Feb 24, 2012

Severity:
Recommended

Clarification of MSX cartridge electrical compatibility

Figure 1. Soldering 10kOhm resistor pack to the cartridge data bus

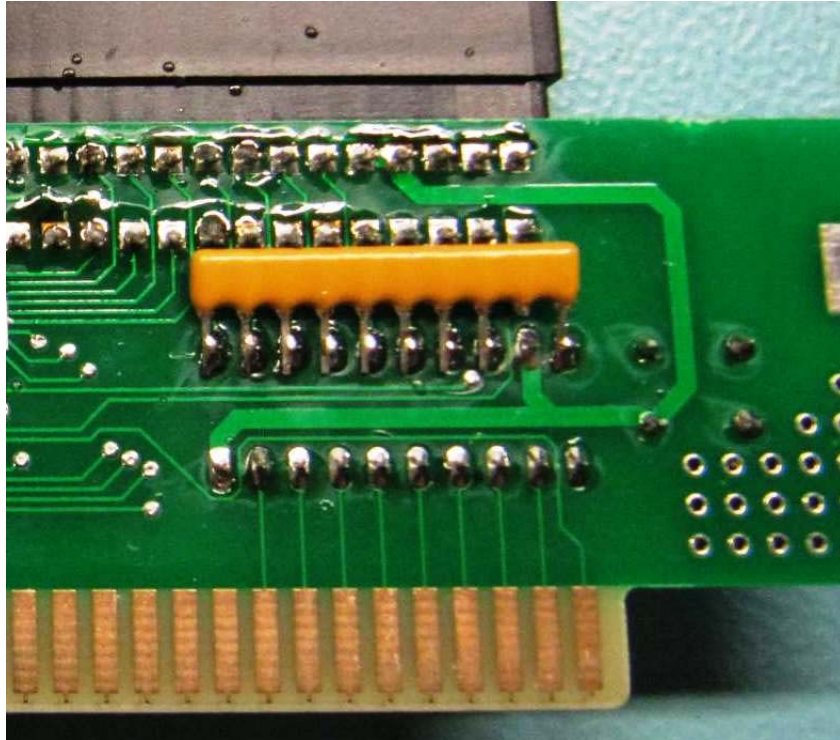
The issue: There's usually a bus buffer between system's CPU and cartridge device, which logically separates CPU data bus and cartridge's data bus. When cartridge is not accessed, its data bus can be subject to be kept at tri-state, causing unintended effect on the cartridge device operation. This effect also may appear during data buffer's switch of data bus direction (for example, when LS245 data bus transceiver is used). This situation is solved by putting pull-up resistors on the cartridge's data bus, but MSX standard does not specify if and which device should hold these pull-up resistors – system or cartridge.

Solution: extensive studies of existing MSX devices and standard itself revealed that it is recommended for cartridges to have pull-up resistors of 10kOhm value at every data, address and control line they use. It is also beneficial for the MSX-compatible system to have 10kOhm resistor pack at cartridge data lines. We recommend you to solder 10kOhm resistor pack to the GR8BUS adapter (interface) boards as shown on fig. 1. Resistor pack should be of 10A103 type, with pin 1 soldered to the pin 20 of IC1 and pin 2 removed. Pack's pins 3-10 are soldered to the data bus from the cartridge side (cartridge data bus). Be careful not to shorten pin 3 of resistor pack (pin 18 of IC1) with closely located via.
